ISSUE	DATE	REVISION
A	16/11/22	DA Submission
B	06/03/23	RFI
C	27/09/23	LEC
D	08/11/23	LEC
E	21/11/23	LEC
F	29/01/24	Amended Issue for LEC

PROJECT
Terrace Houses

ADDRESS
2-6 Martin St, Roselands NSW 2196 Australia

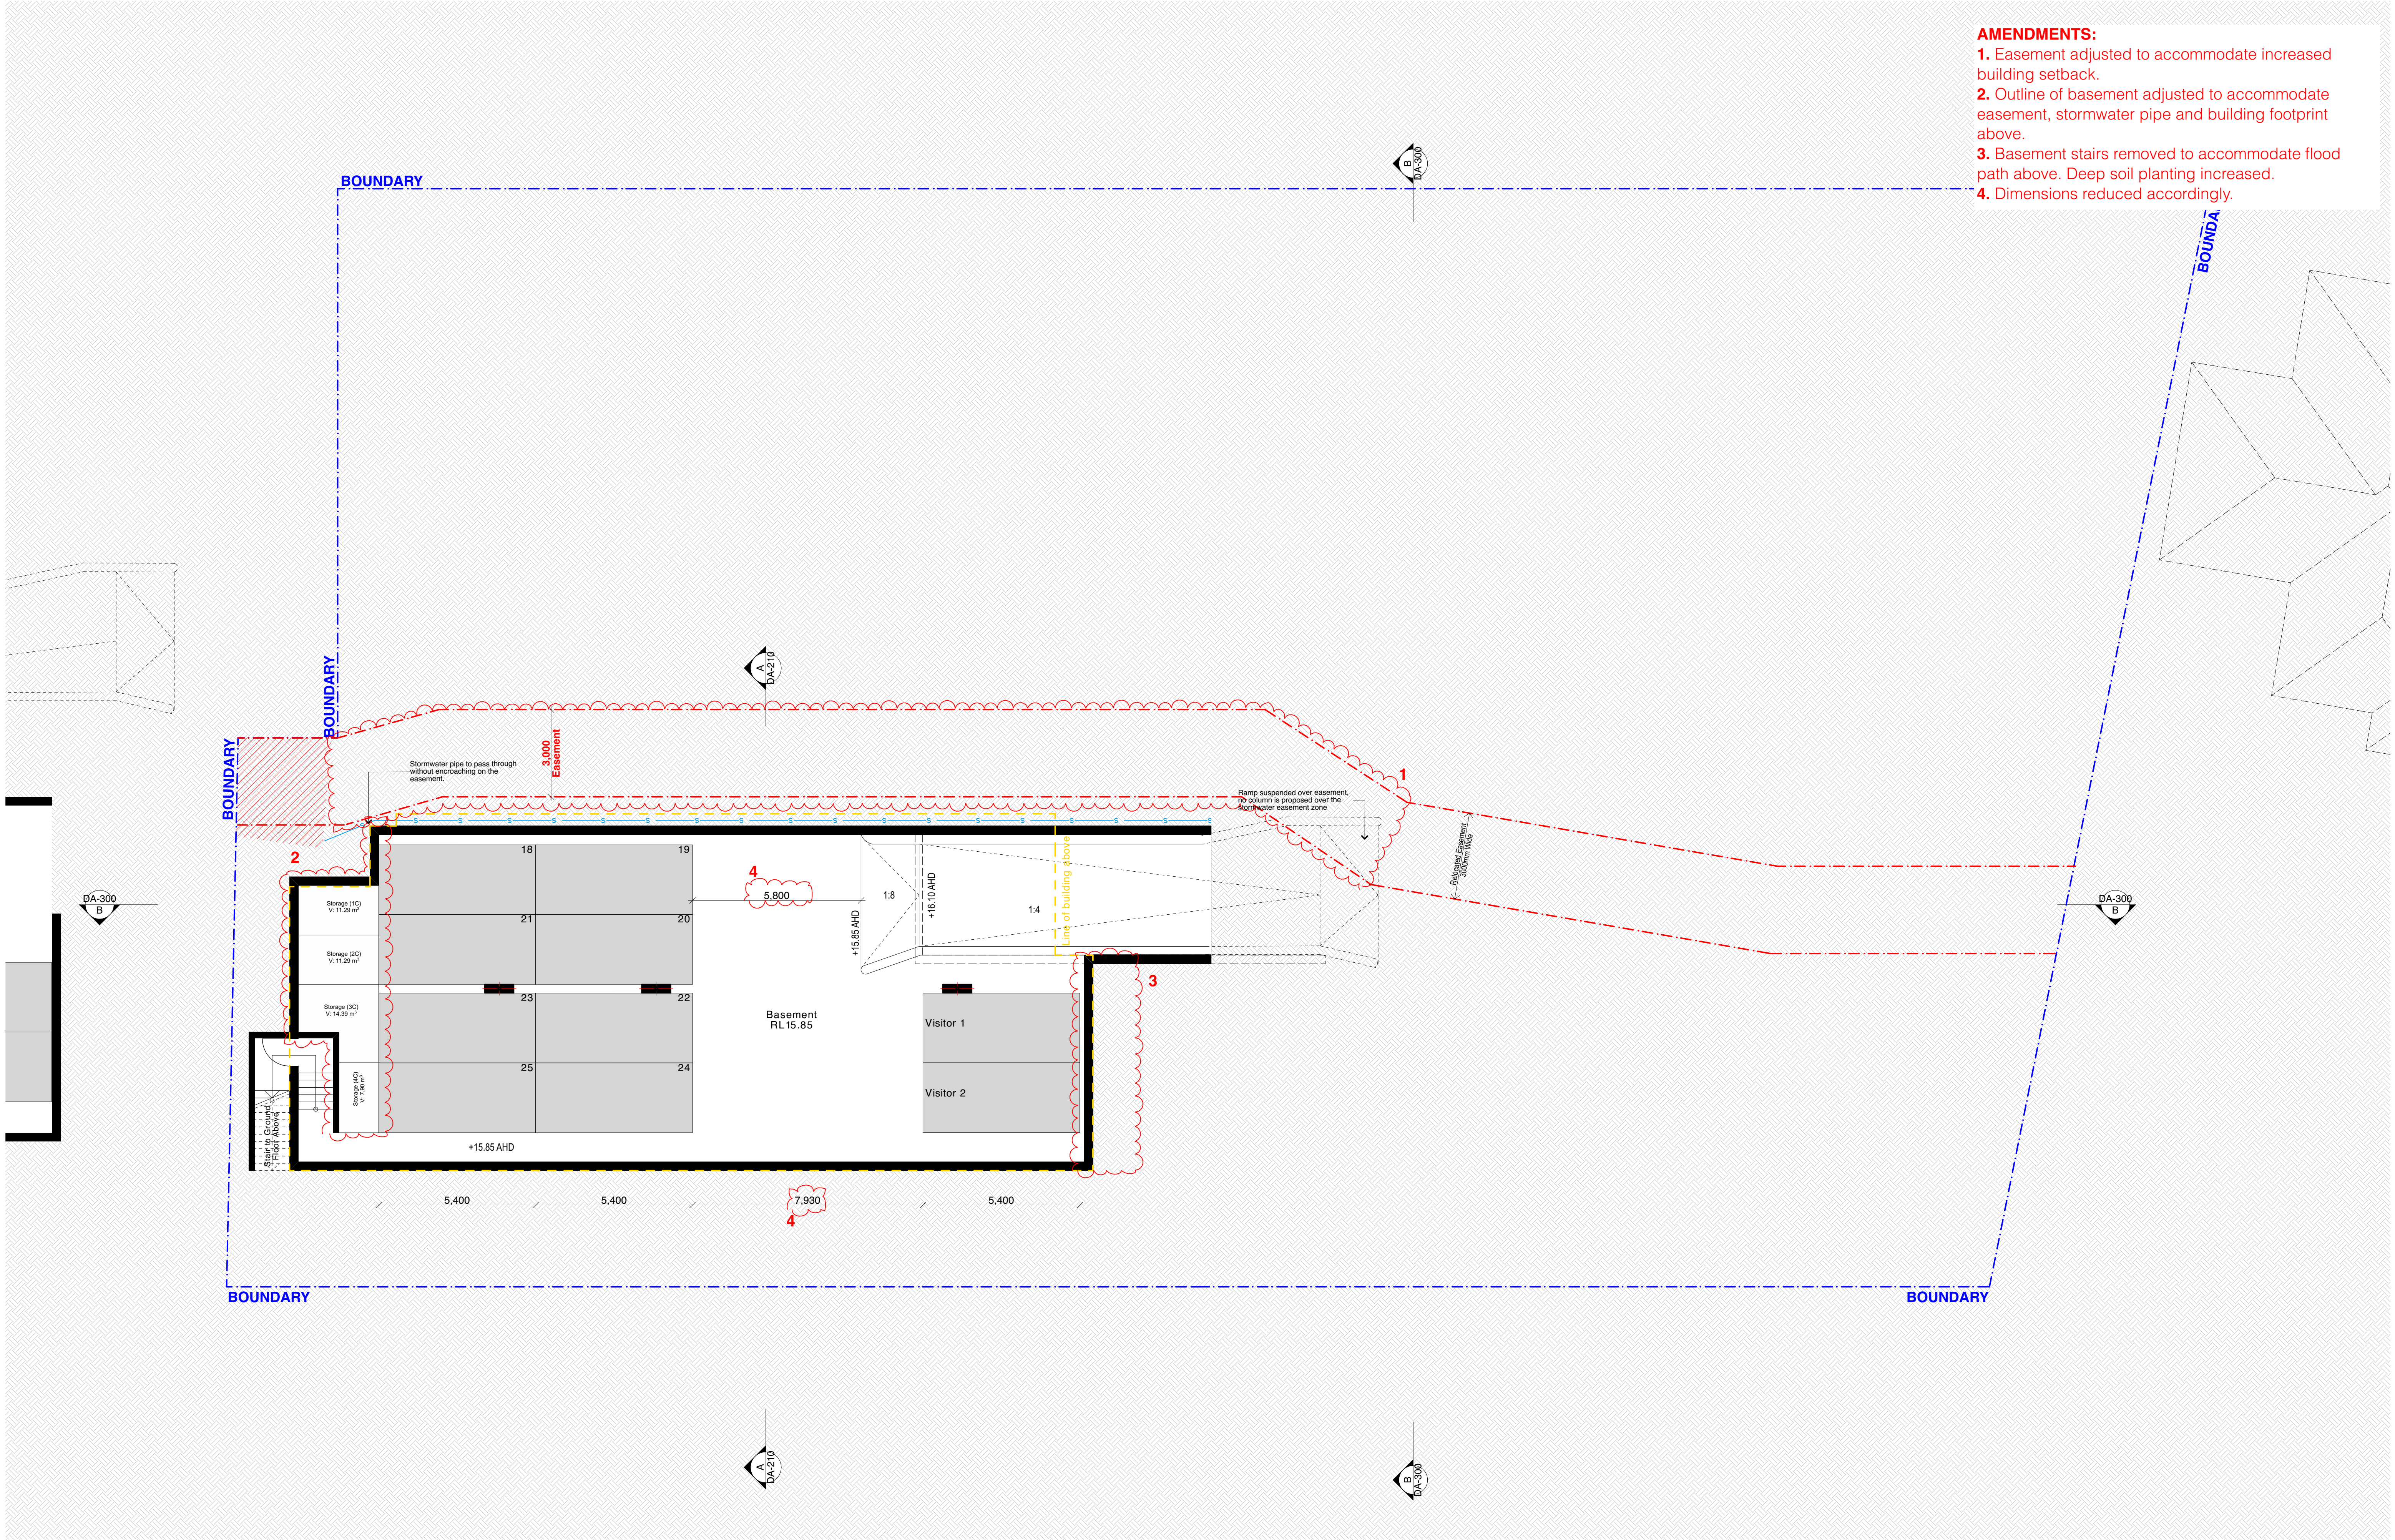
- AMENDMENTS:**
1. Easement adjusted to accommodate increased building setback.
 2. Outline of basement adjusted to accommodate easement, stormwater pipe and building footprint above.
 3. Basement stairs removed to accommodate flood path above. Deep soil planting increased.
 4. Dimensions reduced accordingly.

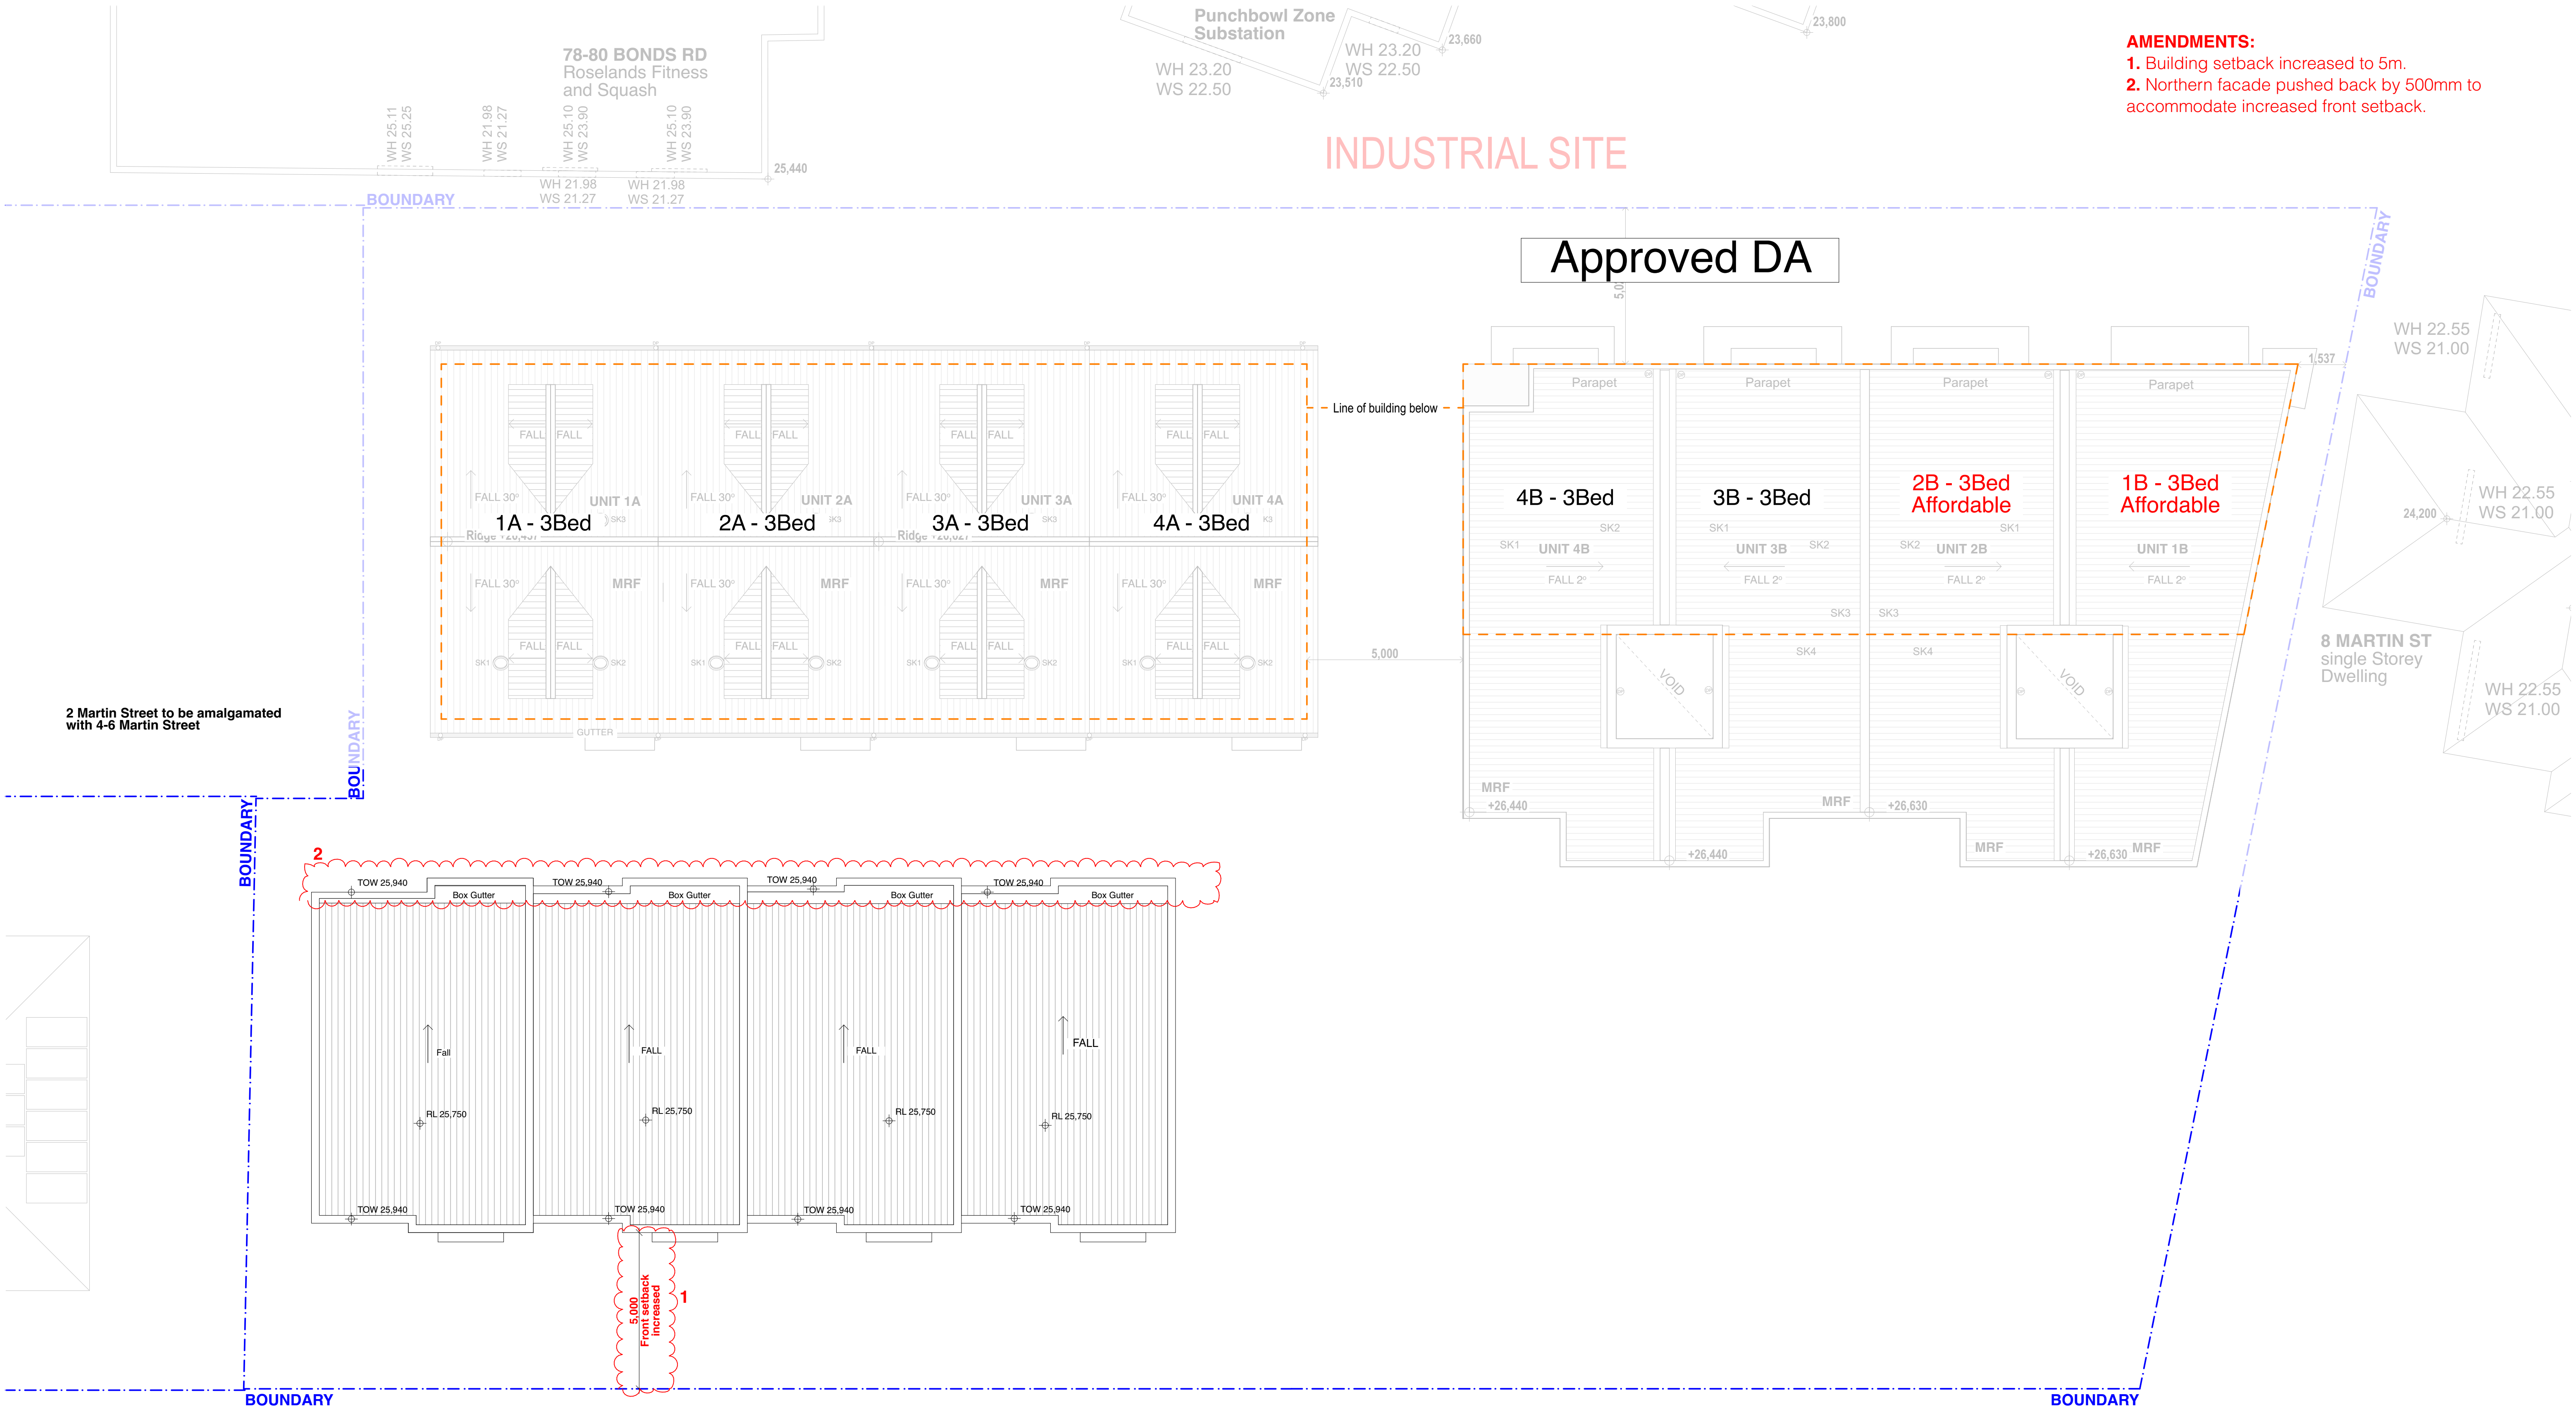
- AMENDMENTS:**
1. Building setback increased to 5m.
 2. Deep soil zone increased to 4m.
 3. Easement adjusted to accommodate increased building setback.
 4. Unit sizes amended accordingly.
 5. Privacy screens to 1C balcony included. Stairs slightly adjusted to avoid easement below.
 6. Pedestrian ramp to rear dwellings relocated.
 7. Raised planter box and basement stair 2 removed to allow for deep soil area and to accommodate flood path.
 8. Pathway adjusted to suit parking spaces.

- AMENDMENTS:**
1. Building setback increased to 5m.
 2. Internal layout adjusted.
 3. Unit sizes amended accordingly.
 4. Northern facade pushed back by 500mm to accommodate increased front setback.
